N63R MAP THERMOSTAT FAULTS

This Service Information bulletin replaces SI B12 13 16 **dated May 2017**

- G30 has been added to the Models affected
- Part Number of thermostat has changed

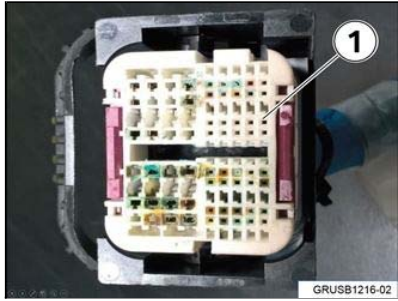
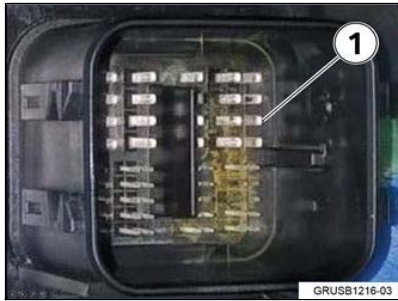
Coolant is leaking past the map thermostat electrical connector.

<p>1. Remove the connector for the map thermostat (1) and check for coolant.</p> <p>Is coolant present in the engine wiring sensor harness for cylinders 1-4?</p> <p>YES - replace the map sensor thermostat (PN 11 53 8 602 282) and the sensor harness (PN 12 51 8 654 414). Go to step 2.</p> <p>NO - continue diagnosis by performing the associated test plan in ISTAD.</p>
	<p>2. Check the wiring harness connector at the DME for coolant (1).</p> <p>Is there any coolant at the DME harness connector?</p> <p>YES – Continue to step 3.</p> <p>NO – Repair is complete.</p>
	<p>3. Check the DME and PDM connector sockets for coolant contamination (1).</p> <p>Is there any contamination at the electrical connectors for the DME or PDM?</p> <p>YES- Submit a TC case to the TC DME group for DME and PDM parts replacement approval</p> <p>NO- Repair is complete.</p>

Replace contaminated components.
